**Project: CPT Apron Reconstruction  
TxDOT CSJ No. 2502CLBRN  
Addendum No. 1  
To Plans and Contract Documents**

## **ADDENDUM NO. 1**

**To:** Attendees  
**From:** Alex Jessop, PE  
**RE:** Cleburne Regional Airport (CPT)  
Apron Reconstruction  
TxDOT CSJ No. 2502CLBRN  
Pre-Bid Meeting Minutes

**1 FULL DEPTH ASPHALT PAVEMENT REMOVAL IN AREAS TO BE RECONSTRUCTED**

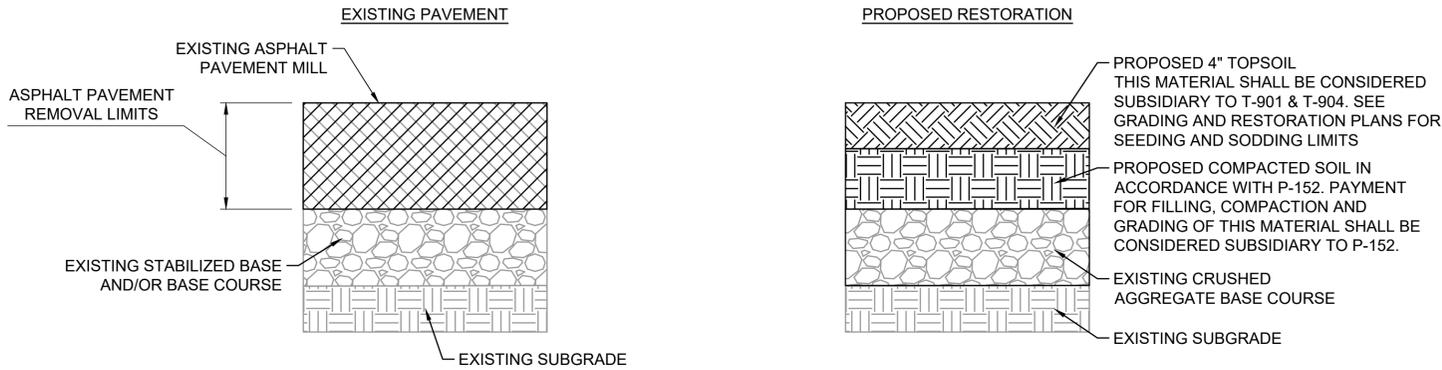
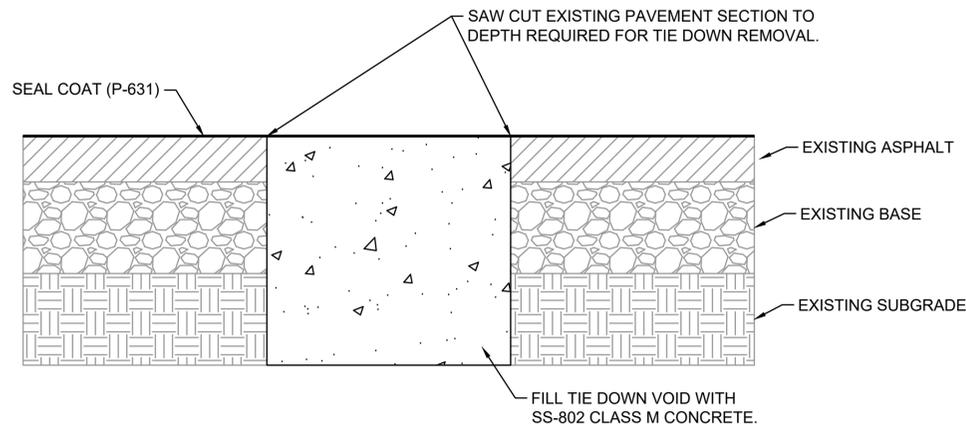
- 7) Is this full-depth pavement removal? Does it include the entire pavement section, base and all?
  - There is full-depth pavement removal that includes the base material for the pavement being removed on Taxiway B where new pavement will be installed. Excavation beyond the base will be quantified as Unclassified Excavation. There is also full-depth pavement removal for the demolition of pavement in areas that will not be reconstructed, to include Taxiway E and the Temporary Taxiway pavement in Phase 1A where turf will be installed. Refer to details 1 & 2 on sheet CD501.
